RESPONSE TO SUBMISSIONS

Springvale Mine Extension Project State Significant Development 5594 Modification 1

October 2016

Figure 2 – Predicted Mine Water Inflow Rates at Springvale Mine for 4.5 Mtpa and 5.5 Mtpa Production Rates (Adapted from CSIRO (2013) and CSIRO (2015))

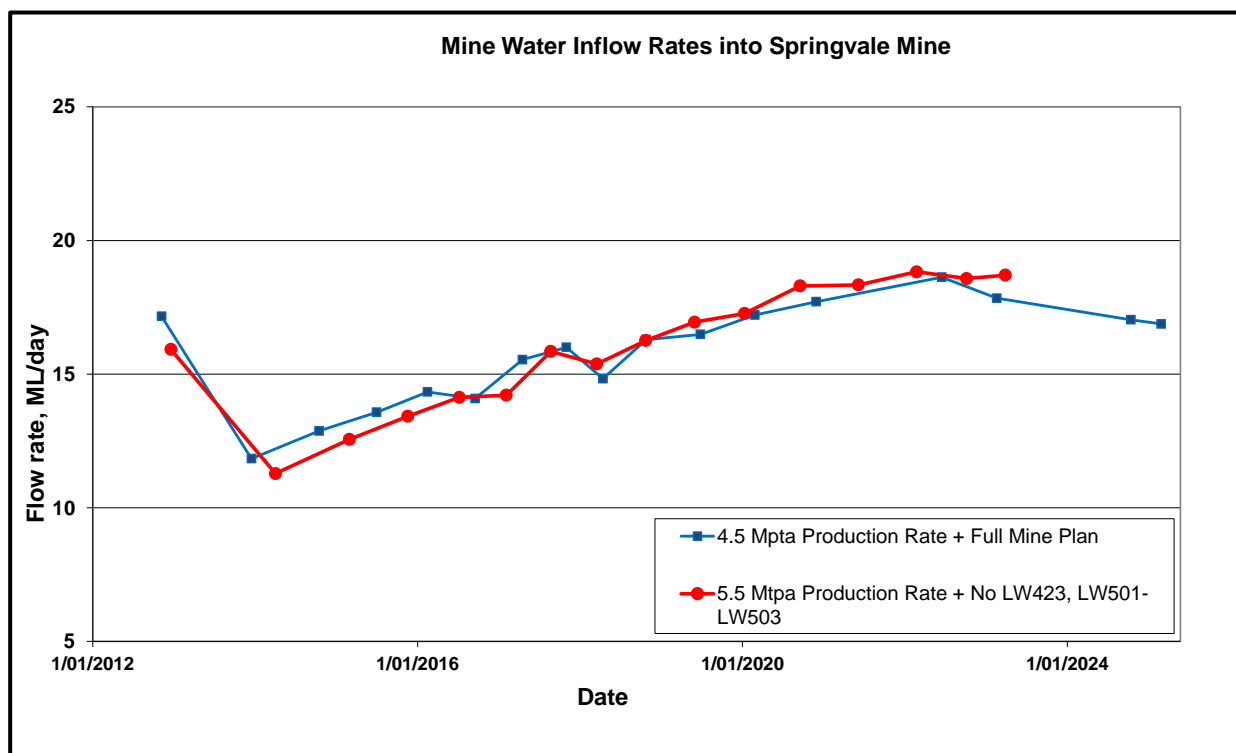
Figures 4.2 and 4.3 of the Jacobs report compare the concurrent and sequential Springvale and Angus Place mining. It would assist the Department’s assessment if you could provide a comparison between the modelled mine inflows for Springvale at the approved production rate of 4.5 Mtpa and predicted mine inflows at a production rate of 5.5 Mtpa, assuming operation of the Springvale only for both cases.

- With reference to Figure 4.3 in the Groundwater Assessment (Jacobs, 2016) adapted from Figure G4 from CSIRO (2015), the “Basecase” simulation (blue trace) represents the inflow predictions to Springvale Mine when the mine was operating concurrently with Angus Place Colliery, as was proposed in the SVMEP EIS, and the production limit assessed for Springvale was up to 4.5 Mtpa. The “SPR then APE” simulation (red trace) are mine inflow predictions to Springvale Mine when the Springvale Mine and Angus Place Colliery are operated sequentially and Angus Place extraction will not commence until Springvale mining operations are completed. The production rates for Springvale Mine in this simulation are as shown in **Table 6**, with the maximum production limit being 5.523 Mtpa in 2022.

- As requested Figure 4.3 has been updated (refer **Figure 2**) to show the two mine inflows simulations for the 4.5 Mtpa and 5.5 Mtpa production limits, however noting that, whilst the 4.5 Mtpa simulation includes the full mine plan the 5.5 Mtpa simulation excluded four longwalls at Springvale Mine (refer to **Section 3.1.2**).

Figure 3 – Predicted Mine Water Inflow Rates at Springvale Mine (Adapted from CSIRO (2013), CSIRO (2015) and CSIRO (2016))

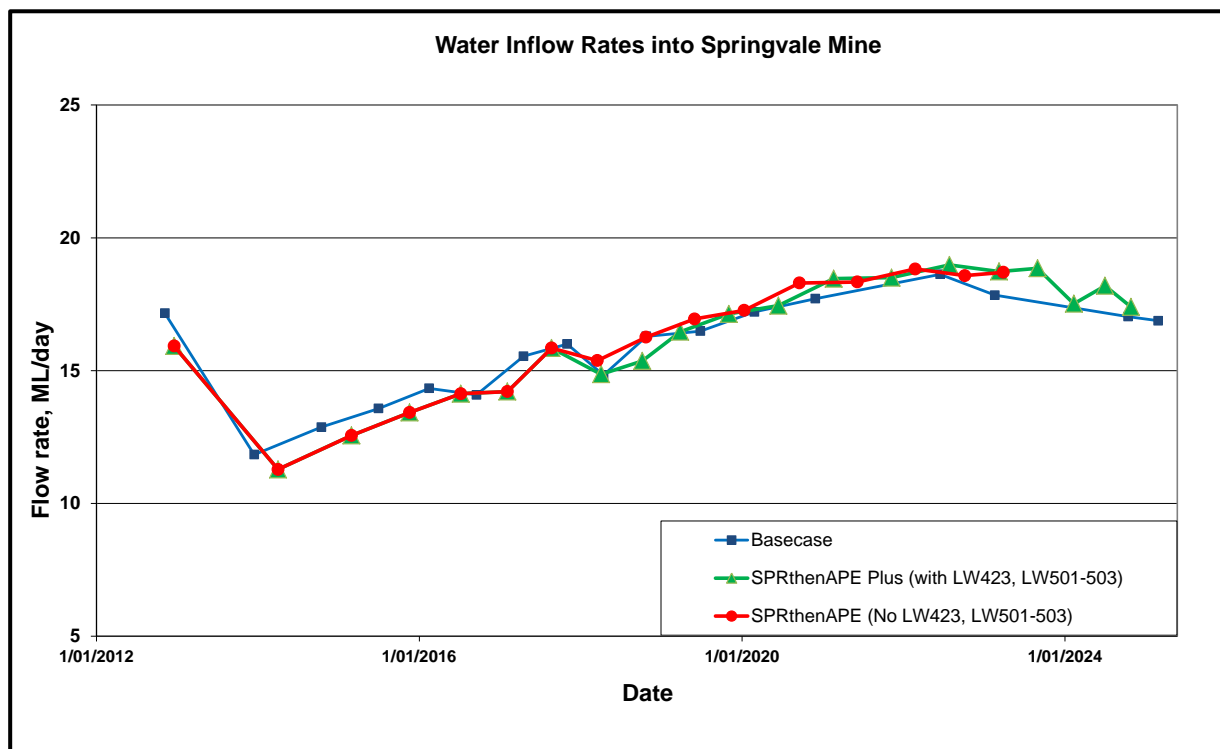
- (ii) *if the “Basecase” has been redeveloped in each situation using the 2015 NGM, then the blue curve in Figure 4.2 should be different to that which was used in the Extension EIS (Appendix K to Appendix E of MEP 2014, being Figure 64 in CSIRO (2013) shown as the blue curve in that figure - it does not appear to be different;*

“the value of the flow rate for the ‘Basecase’ in Figure 4.2 (about 440 L/s) should equal the addition of the value of the blue line in Figure 4.3 – flow rate about 200 L/s, plus the value of the blue line in Figure 4.3 – flow rate about 140 L/s – i.e. a total of about 340 L/s.”

To resolve this issue, additional simulations of the COSFLOW model developed in 2013 were undertaken by the CSIRO, and their report (CSIRO, 2016) is attached as Appendix A to **Appendix C** of the RTS. **Figure 3** (adapted from CSIRO (2016) and CSIRO (2015)) below presents the Springvale Mine inflow results, on a single graph, with respect to ‘Basecase’ (as approved in SSD 5594), ‘SPR then APE’ (sequential implementation without Springvale Mine’s approved longwalls LW423 and LW501 to LW503) and ‘SPR then APE Plus’ (sequential implementation, but including LW423 and LW501 to LW503).

From **Figure 3**, modelling indicates the inclusion of LW423 and LW501 to 503 was not consequential to the results presented in CSIRO (2015). The statement in Jacobs (2016a) quoted above is therefore considered to have been validated. Generalising, the reason why LW423 and LW501 to 503 have a minimal impact to mine inflows is because depressurisation in the vicinity has already occurred.

Figure 2.1 : Predicted Mine Inflow Rates (adapted from Adhikary and Wilkins (2013), Adhikary and Wilkins (2015) and Adhikary (2016))

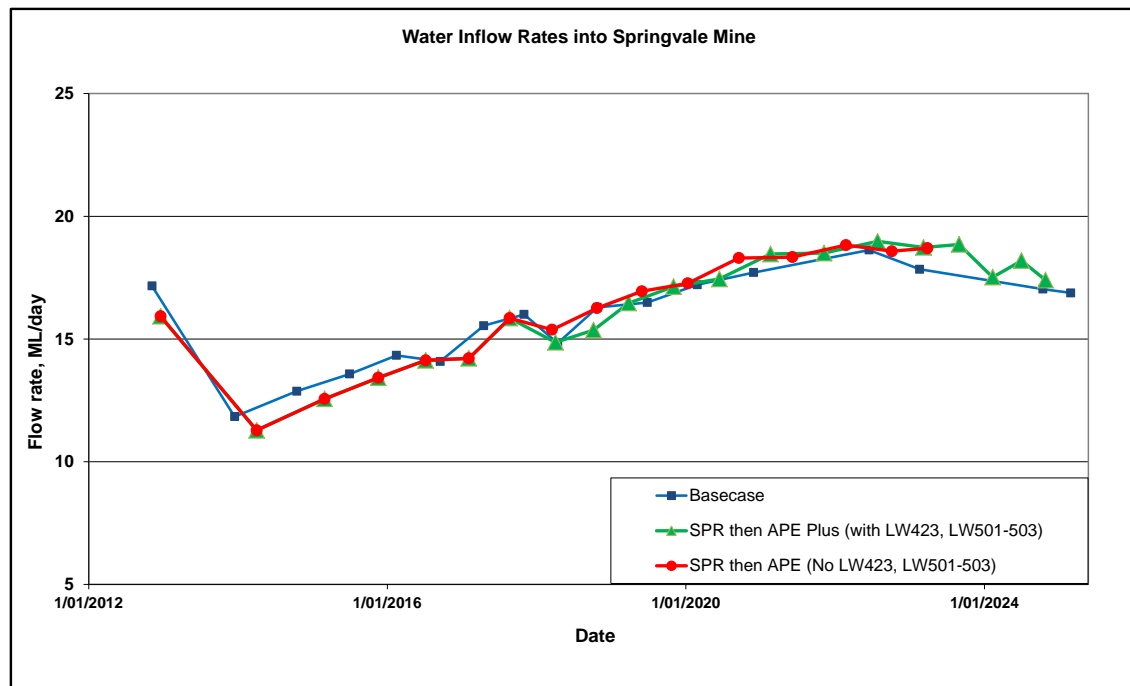
(ii) if the “Basecase” been redeveloped in each situation using the 2015 NGM, then the blue curve in Figure 4.2 should be different to that which was used in the Extension EIS (Appendix K to Appendix E of MEP 2014, being Figure 64 in CSIRO (2013) shown as the blue curve in that figure - it does not appear to be different;

the value of the flow rate for the ‘Basecase’ in Figure 4.2 (about 440 L/s) should equal the addition of the value of the blue line in Figure 4.3 – flow rate about 200 L/s, plus the value of the blue line in Figure 4.3 – flow rate about 140 L/s – i.e. a total of about 340 L/s.

To resolve this issue, additional simulations of the COSFLOW model were undertaken by the CSIRO, and their report is attached as Appendix A (Adhikary, 2016). **Figure 2.1** (adapted from Figure 1 of Adhikary (2016) to include the ‘Basecase’) below presents the Springvale Mine inflow results, on a single graph, with respect to ‘SPR then APE’ (sequential implementation without Springvale Mine’s approved longwalls LW423 and LW501 to LW503) and ‘SPR then APE Plus’ (sequential implementation, but including LW423 and LW501 to LW503).

From **Figure 2.1**, modelling indicates the inclusion of LW423 and LW501 to 503 was not consequential to the results presented in Adhikary and Wilkins (2015). The statement in Jacobs (2016a) quoted above is therefore considered to have been validated. Generalising, the reason why LW423 and LW501 to 503 have a minimal impact to mine inflows is because depressurisation in the vicinity has already occurred.
